HISTORIC PRESERVATION BOARD AGENDA

Request approval of a Certificate of Appropriateness for fencing and landscaping in the front yard for the property located at 515 N 7th Street, a Contributing Structure in the North 7th Street Historic District

Certificate of Appropriateness Review Fencing and Landscaping

515 North 7th Street

515 North 7th Street Proposed Site Plan

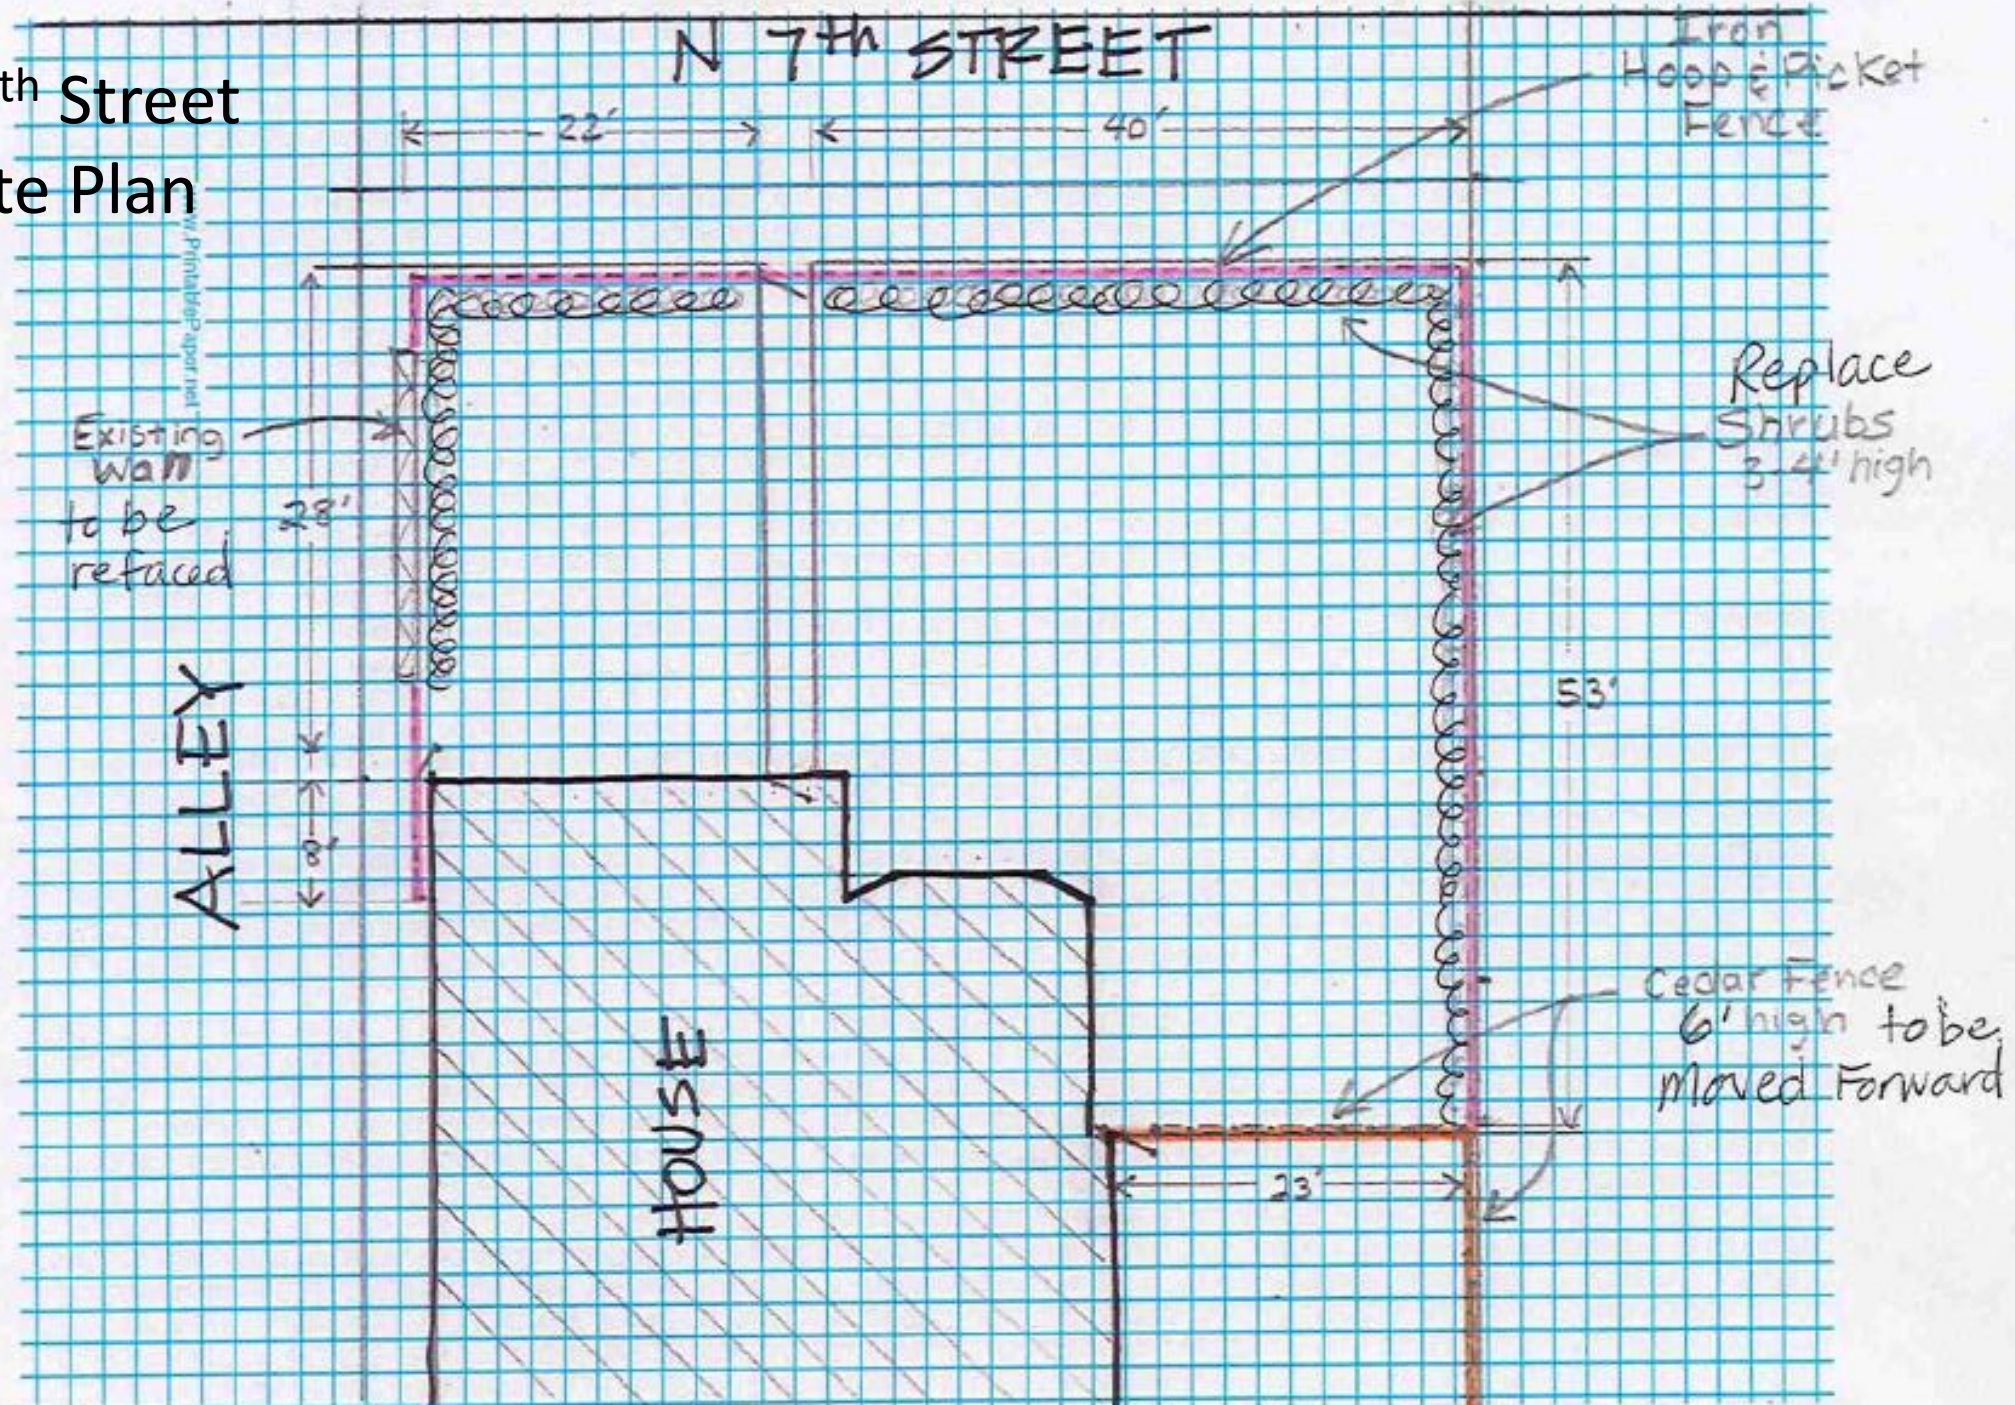
Proposed
spear and
hoop
fence

Existing 6-foot
wooden privacy fence
to be forward to 53
feet from front
property line

Existing low wall along alley – to be refaced with flagstone to match other existing walls on the property
